PATRIOT PLACE SUBDIVISION - A

A REPLAT OF LOTS 1 & 2, PATRIOT PLACE, LOCATED IN THE SOUTHWEST QUARTER OF SECTION 11,
TOWNSHIP 11 SOUTH, RANGE 67 WEST OF THE 6TH P.M.,
COUNTY OF EL PASO, STATE OF COLORADO

FINAL PLAT
PATRIOT PLACE SUBDIVISION - A

Final Plat Drawings_V3.pdf Markup Summary

SHEET 1 OF 2

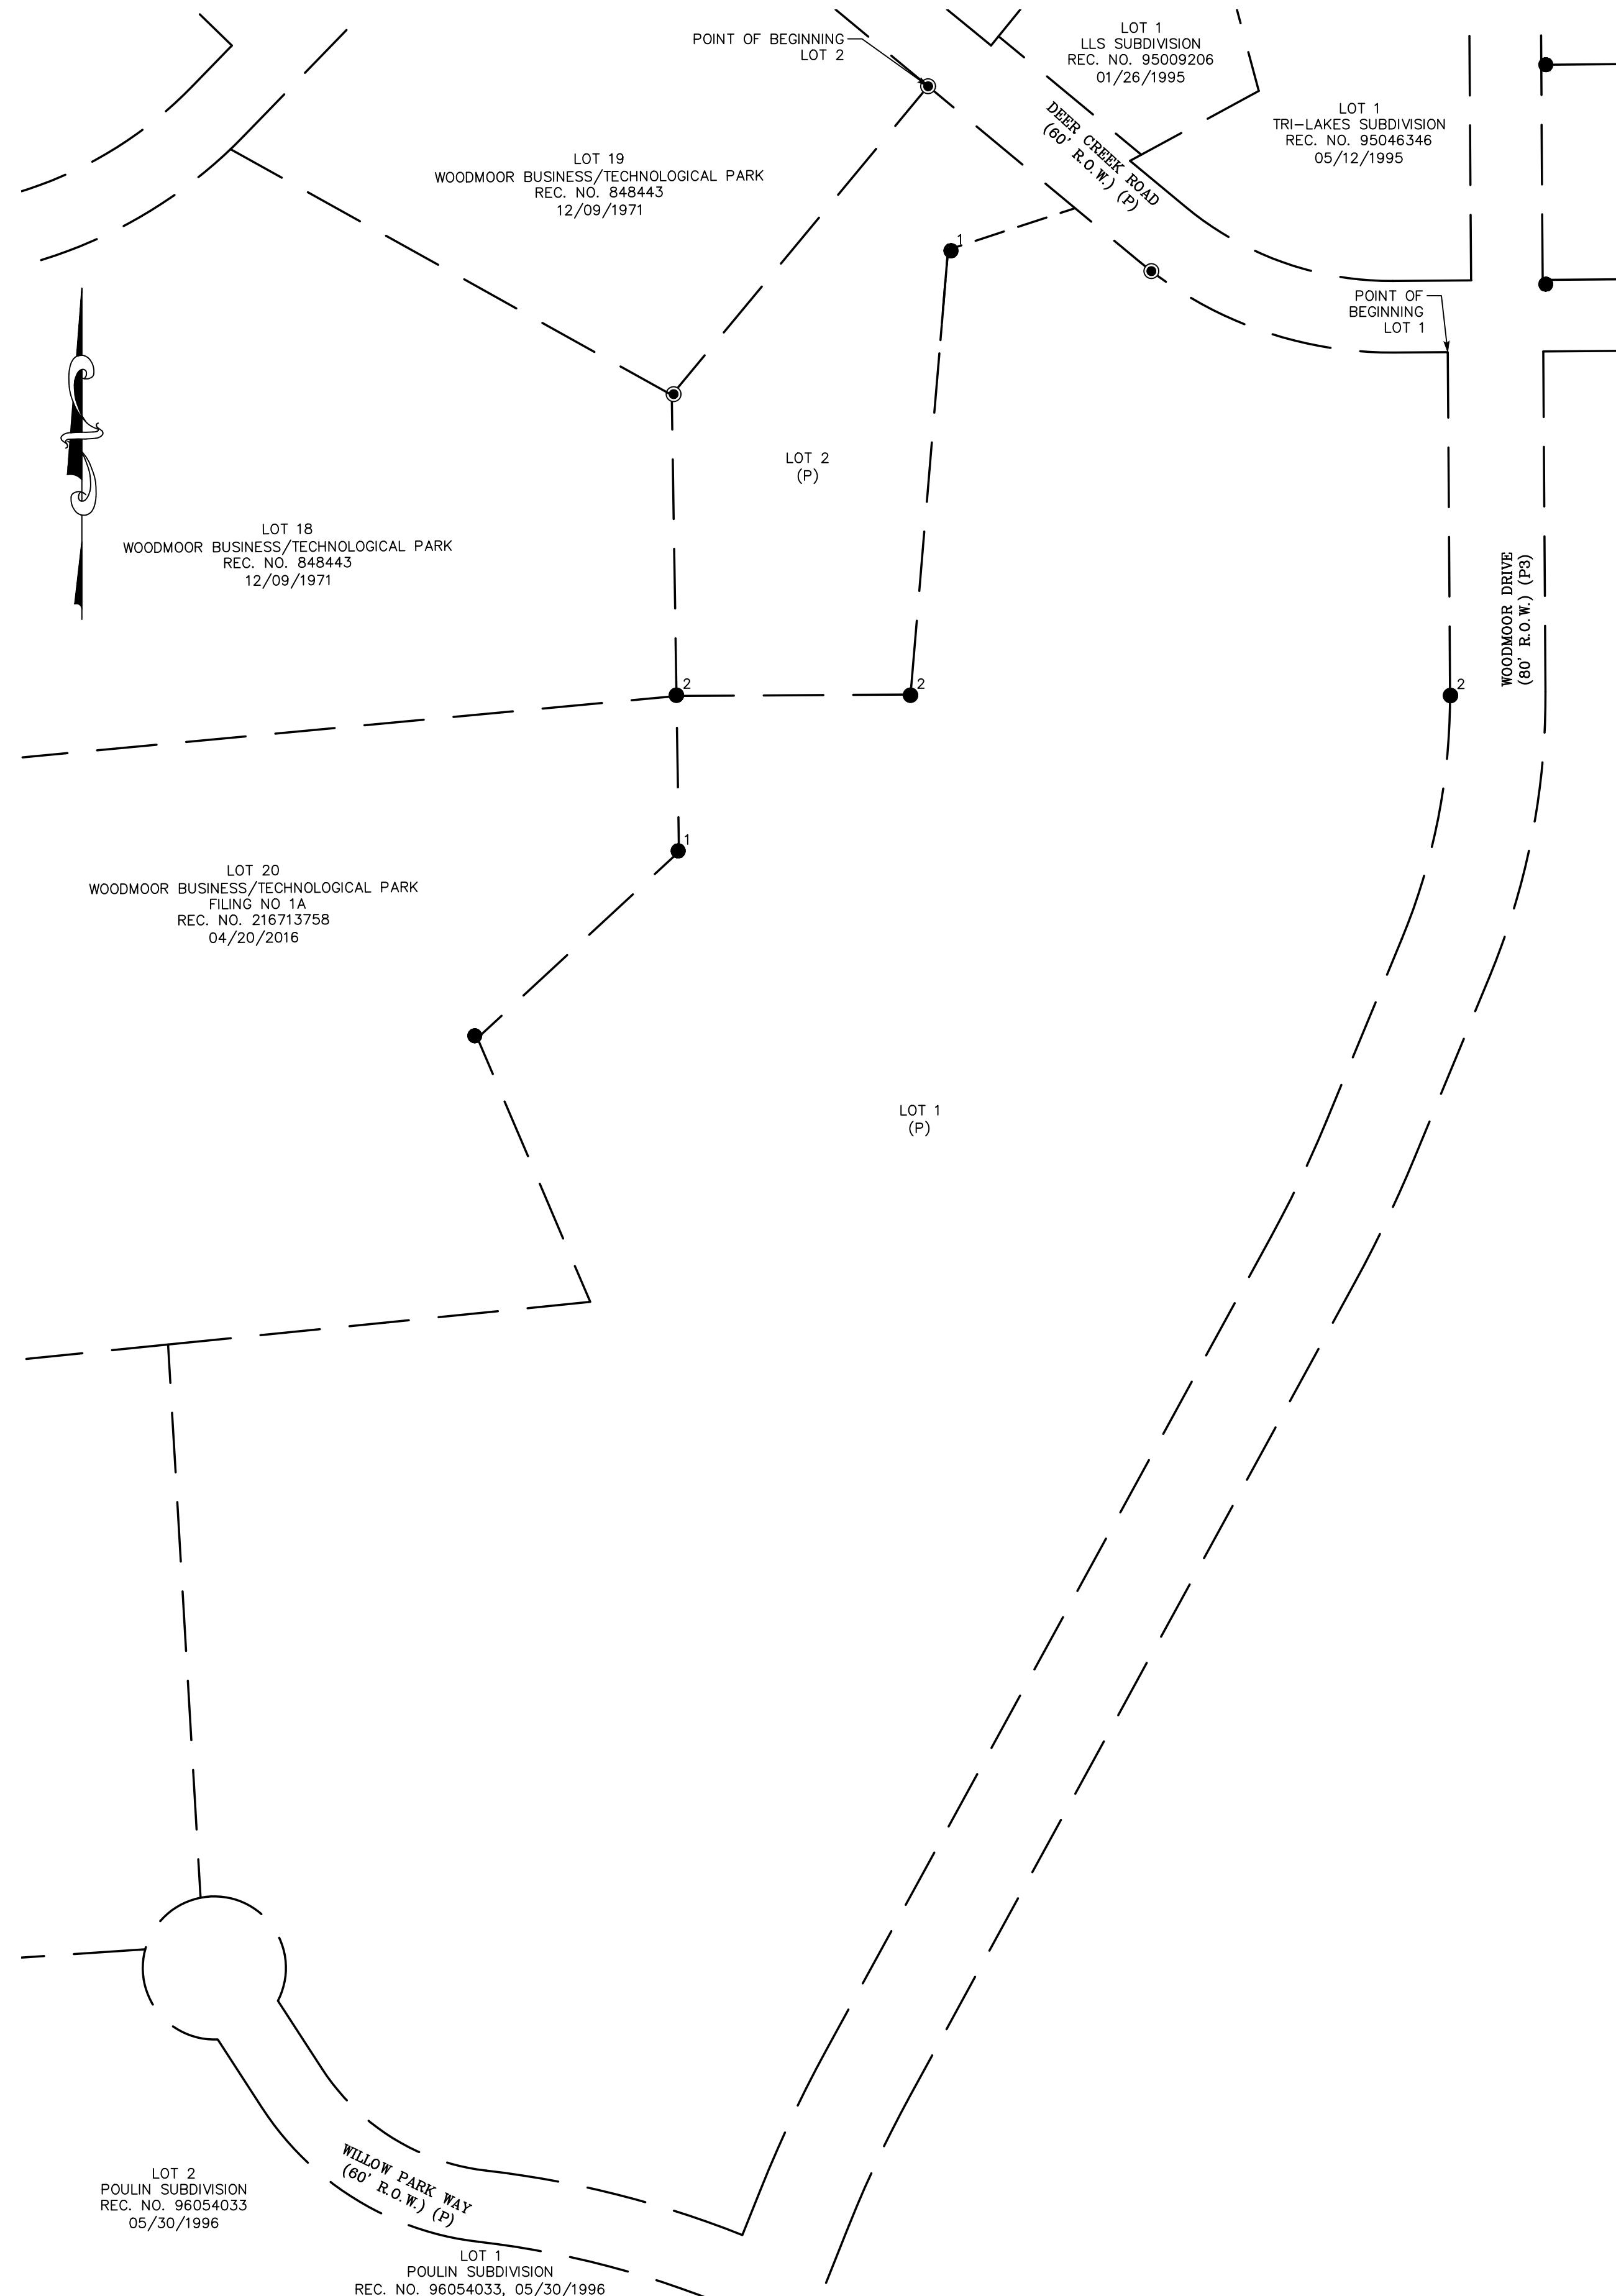
[repeat comment]:
This plat is approved by the PCD Director, not Board of County Commissioners.
please revise heading to reflect this is to be approved by the PCD Director

Please insert name of subdivision/plot "Patriot Place Subdivision - A"

[repeat comment]: . This plat is approved by the PCD Director, not Board of County Commissioners. please revise heading to reflect this is to be approved by the PCD Director

SHEET 2 OF 2

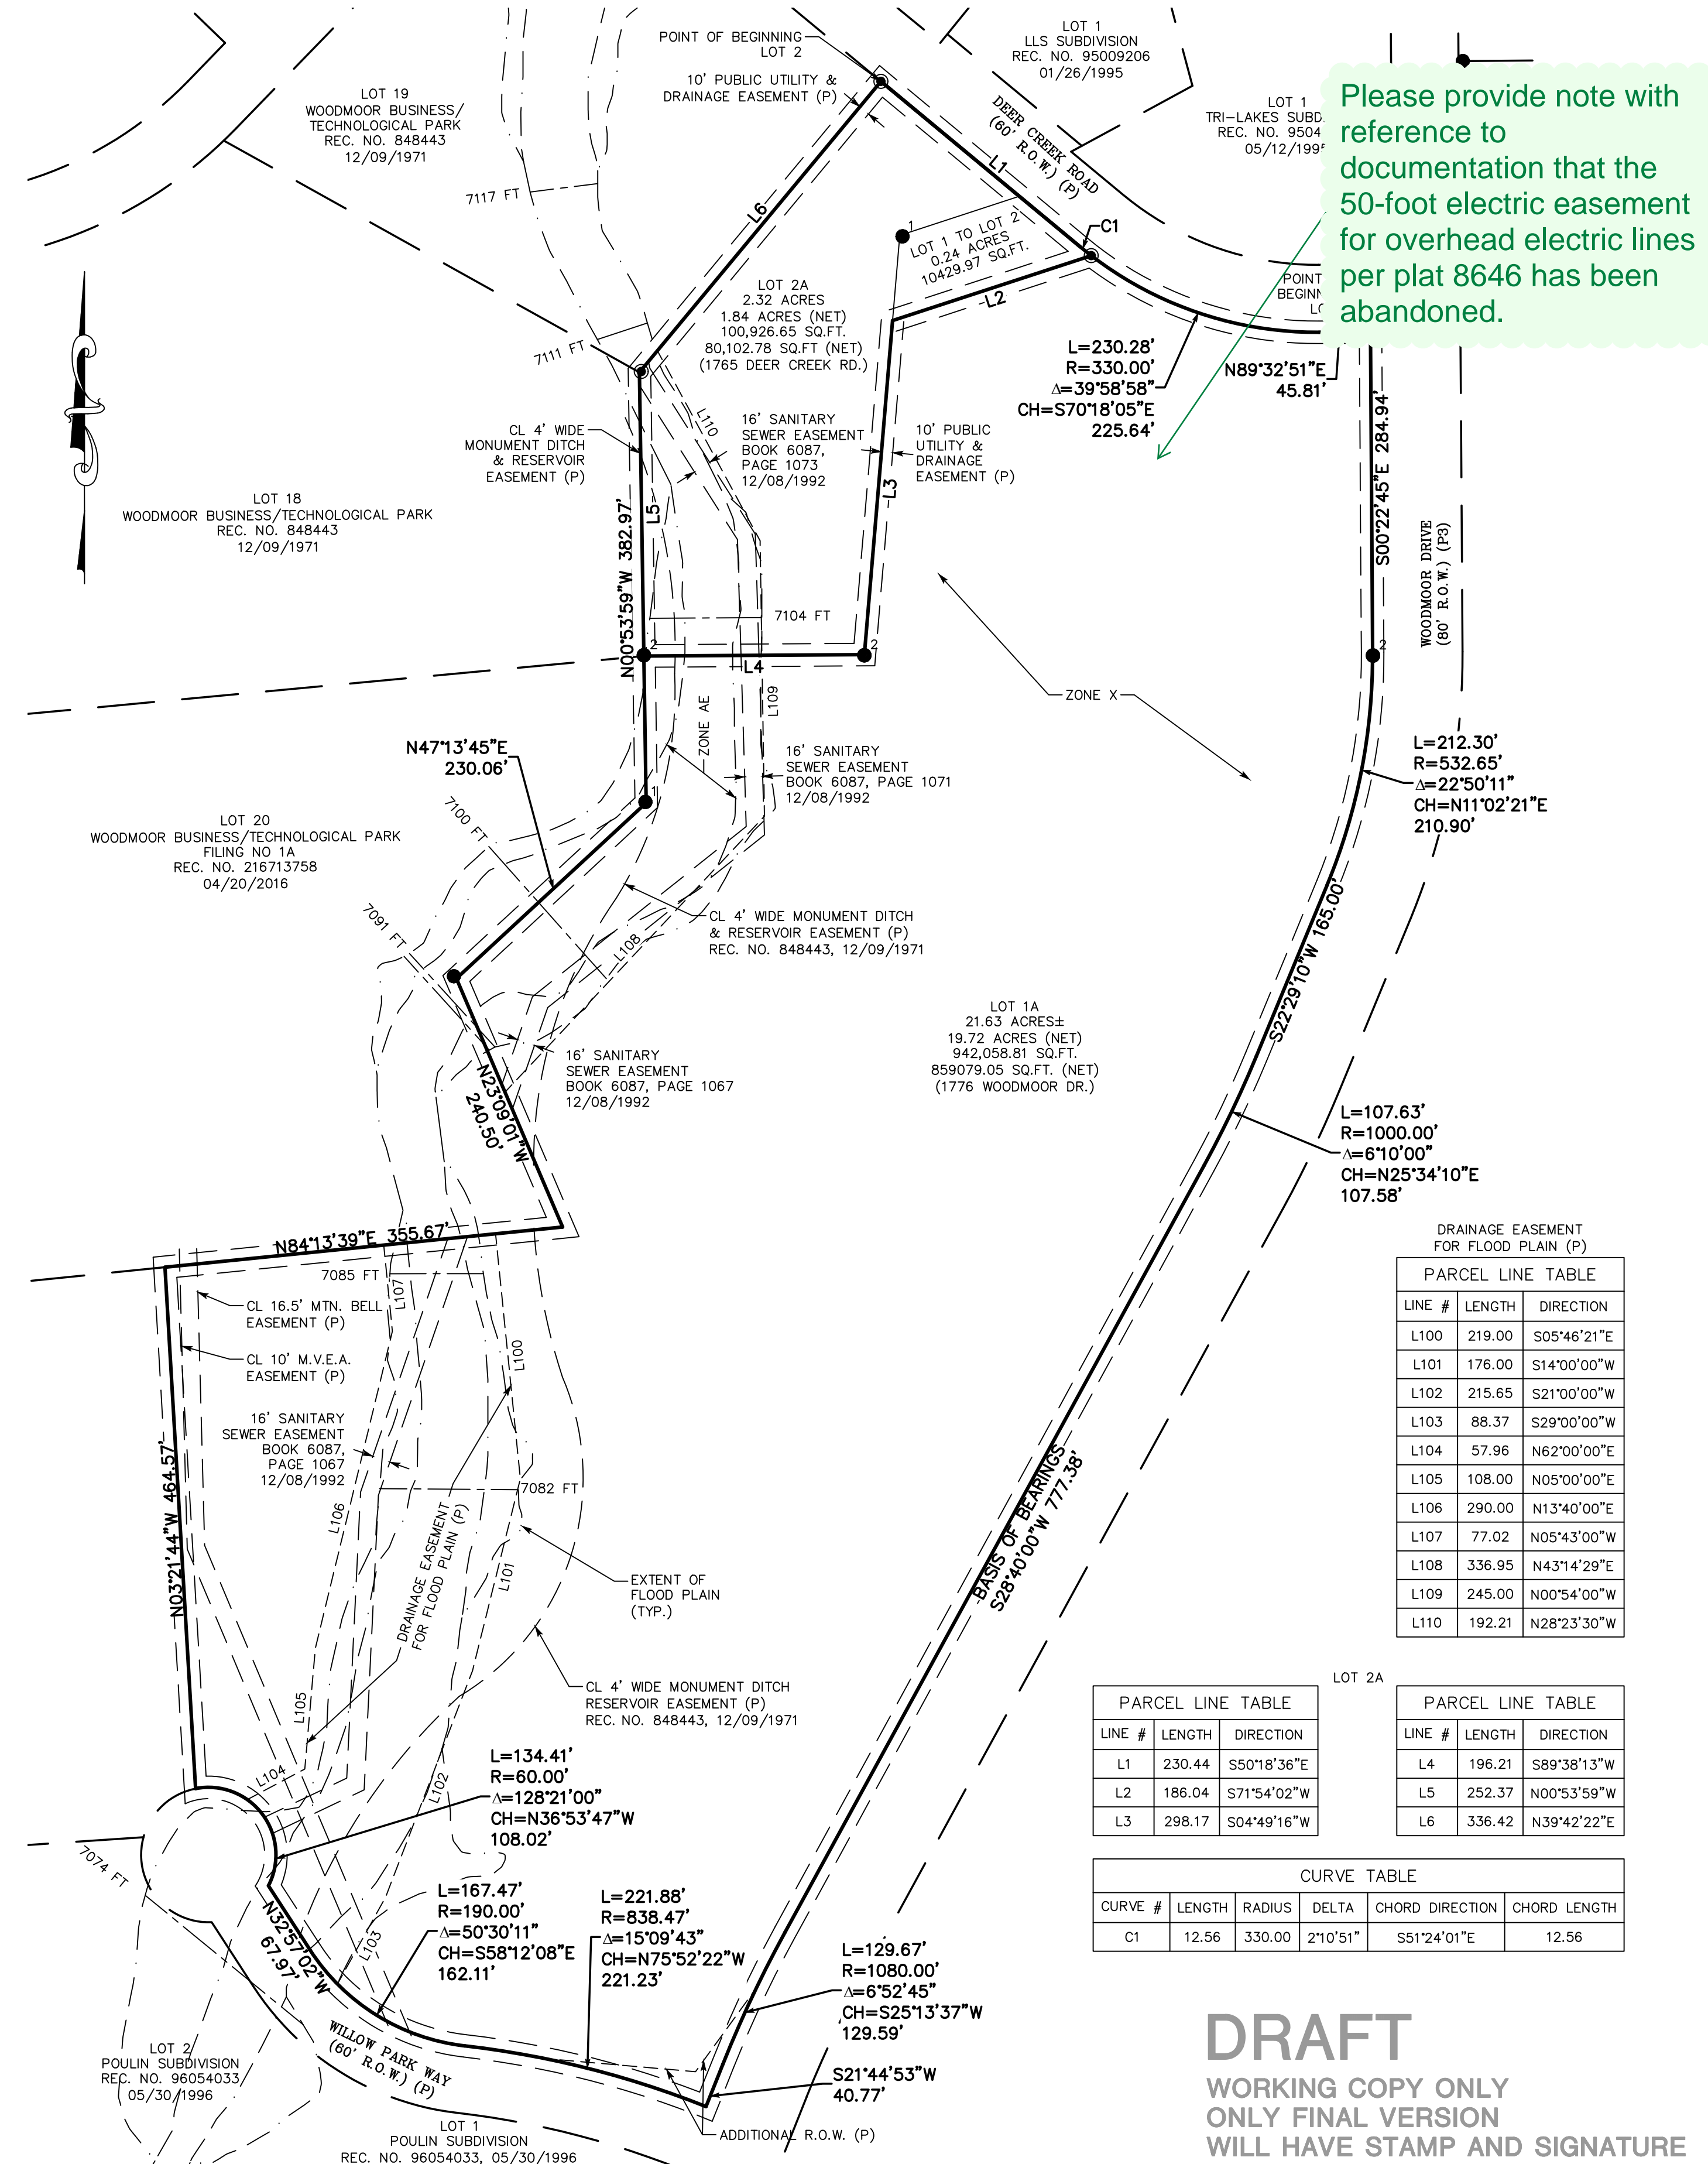
Please provide note with reference to documentation that the 50-foot electric easement for overhead electric lines per plat 8646 has been abandoned.

Please provide note with reference to documentation that the 50-foot electric easement for overhead electric lines per plat 8646 has been abandoned.
